APPLICATION NO.	FILING DATE	FIRST NAMED INVENTOR	ATTORNEY DOCKET NO.	CONFIRMATION NO.
10/751,337	01/02/2004	Hans-Gerhard Kortmann	0275M-000845	7611

Office Action Summary

DETAILED ACTION

Fig. 3

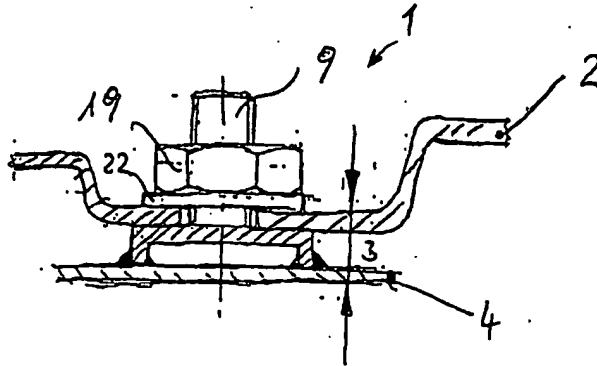
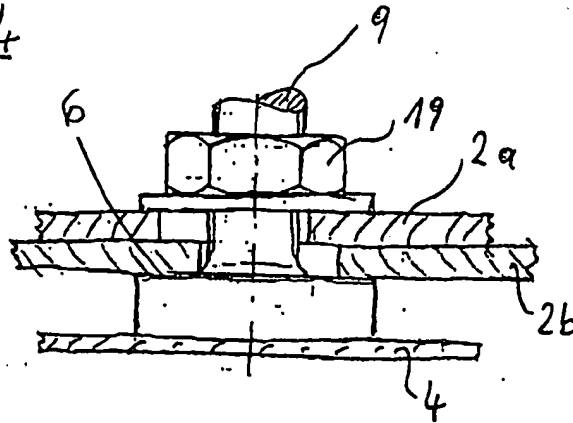
- [2] The replacement drawing sheets submitted on 21 February 2005 have been approved and entered by the examiner. Accordingly, all objections to the drawings are withdrawn. Although Figures 3 and 4 appear unclean and hand-sketched, all features disclosed are legible.
